MEMO

From: Adrienne Nelson, Associate Planner

Re: Certificate of Appropriateness – 301 W 7th Street

PROPOSED SOUTH ELEVATION
SCALE: 3/16 = 1'-0"

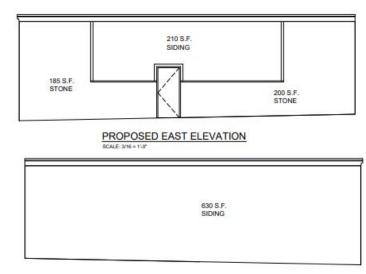
The owners of 301 W 17th Street are requesting a Certificate of Appropriateness for the planned addition to their building. The material to be used for the façade is stone veneer and LP Smartside. They are not planning to update the façade of their existing structure at this time but plan to in the future.

Grant a Certificate of Appropriateness to 301 W 7^{th} Street for the project as proposed.
